**Final Environmental Assessment
Montana Tunnels Mining Inc.
(MTMI)
Reclamation Plan Update**

**PREPARED BY
MONTANA DEPARTMENT OF ENVIRONMENTAL QUALITY
HARD ROCK MINING BUREAU**

JULY 24, 2020

Attachment 1 - Response to Comments

FWP-8

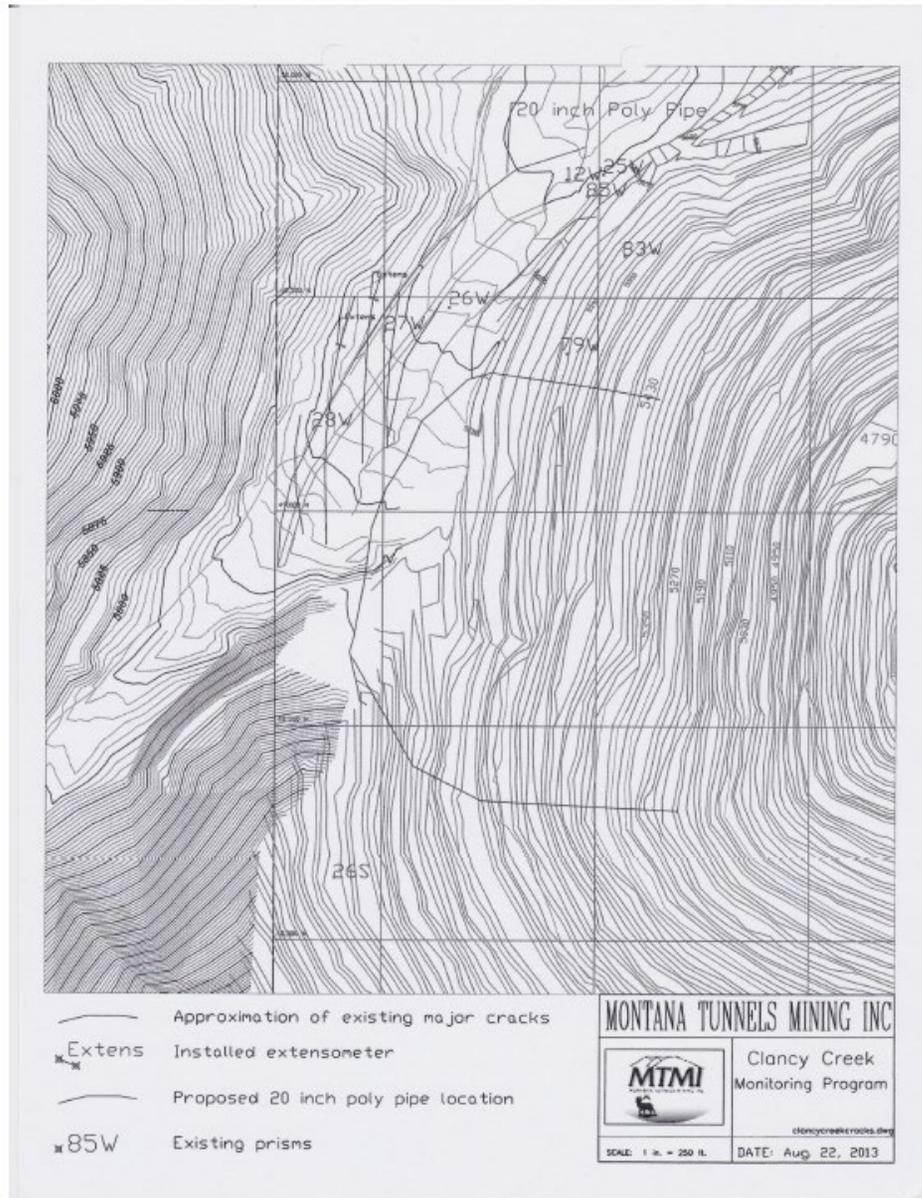
FWP comment: Failure to accurately predict extent of pit slumping effects in 1986 and 2008 related to Clancy Creek should not be repeated in the future. The expected location of the future pit boundary related to Clancy Creek should be studied in detail before money is invested to move the stream. FWP-8

See response to FWP-3. These issues would be addressed during final engineering design prior to construction of the channel. The purpose and need is to have Clancy Creek flowing in a more natural state than in a pipeline to increase the aquatic habitat. DEQ can require bonding to ensure adequate engineering review during final design, but cannot require or conduct any channel relocation without first amending the mine's reclamation plan.

NGO-1

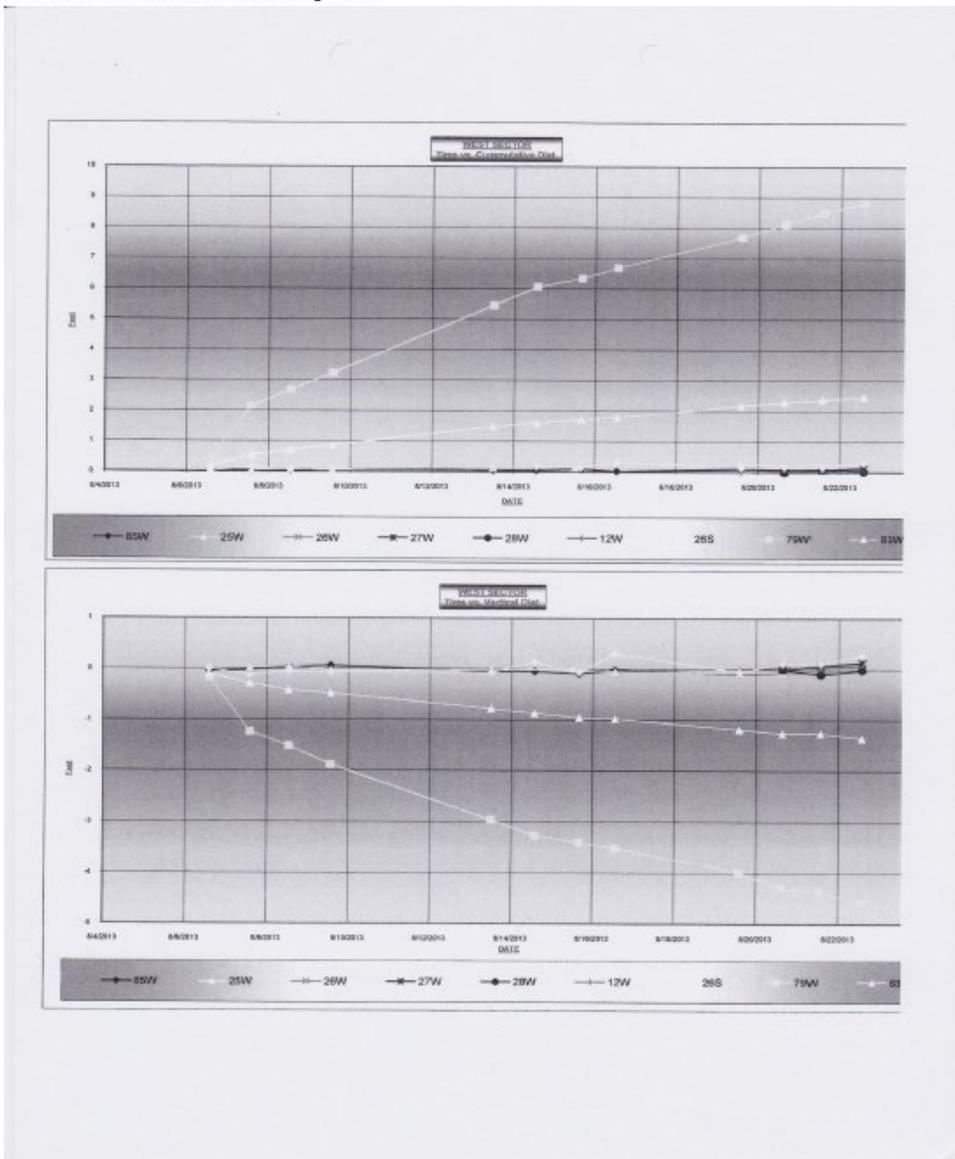
MTMI also appeared to collect data on the movement/expansion of the tension cracks over time. This information, along with a more current assessment should be included in the EA to evaluate risk and to inform reclamation plans. NGO-14

Additional bond was posted by MTMI as required up through 2007. The bond was considered to be adequate to fulfill the reclamation plan at that time. In 2008 a mine expansion was approved, pending the submittal of additional bond to cover the expansion plan. As part of that expansion plan, stability issues associated with the existing pit and Clancy Creek would have been addressed. However, due at least in part to the "Great Recession" of 2008, MTMI did not have capital and could not secure additional funding to either post the additional required bond or fund the up-front costs associated with initiating the mine expansion. Since that time, MTMI has continued to seek investors to fund the re-opening of the mine but has not been successful in securing funding. Meanwhile, calculated costs of reclamation for the previously approved closure plan have increased, and additional potential costs associated with remediation of pit wall stability issues that have developed since the cessation of mining in 2008 have been recognized. This permit amendment, initiated by the DEQ to address stability issues that were not identified at the time the previous mine plan (L-Pit) was approved and bonded, is intended to update the existing reclamation plan to address these issues and to enable DEQ to request additional bond to cover reclamation expenses associated with remediation of impacts related to pit wall subsidence.
